# **Statement of Response to ABP's Opinion**

**Proposed Development at Block 2, Spencer Dock, Dublin 1**

**John Spain Associates**

**August 2019**

Figure 3: Existing and proposed building heights in City Block 2 (one additional set back floor is also possible in the proposed amendments)

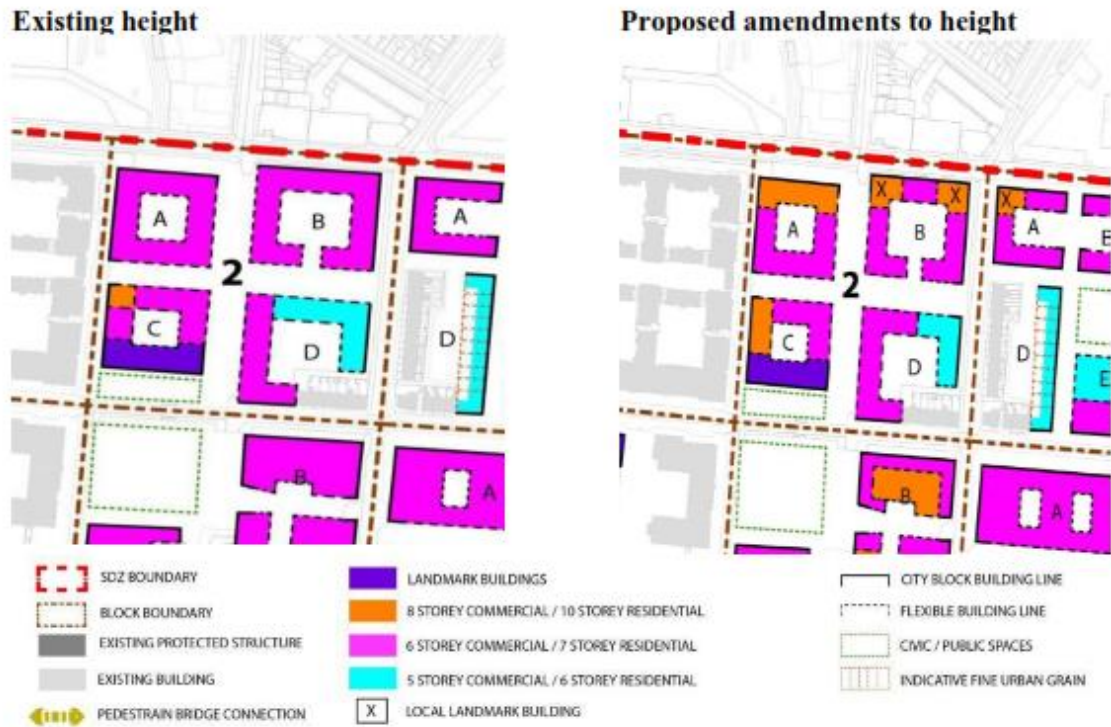
2.20 The proposed amendments to the planning scheme submitted to An Bord Pleanála by Dublin City Council and the Development Agency in May 2019 has increased the building height permissible within Block 2 which enables greater heights on the subject site compared to the current SDZ planning scheme. The proposed amendments seek to provide building heights of up to 12 no. storeys in the north west and north east corners, with 6/ 7 no. storeys residential plus one set back, i.e. a building height of 7 to 8 no. storeys residential for the remainder of the subject site.

2.24 In the remainder of Block 2B and 2D (the subject site), the proposed amendments provide for a range of 7 to 8 no. storeys in height including an additional set back floors as proposed in the amendments. Section 5.4.5 of the SDZ is also amended to include the potential of a set back floor on top of the height stated per block. The proposed development is therefore is largely compliant with this aspect of the planning scheme.

2.29 In addition, the proposed amendments to the planning scheme enable 1 no. set back floor to be provided on top of the permissible building heights on City Block 2, enabling 7 no. storeys with a set back 8<sup>th</sup> storey level to be permissible on the site.
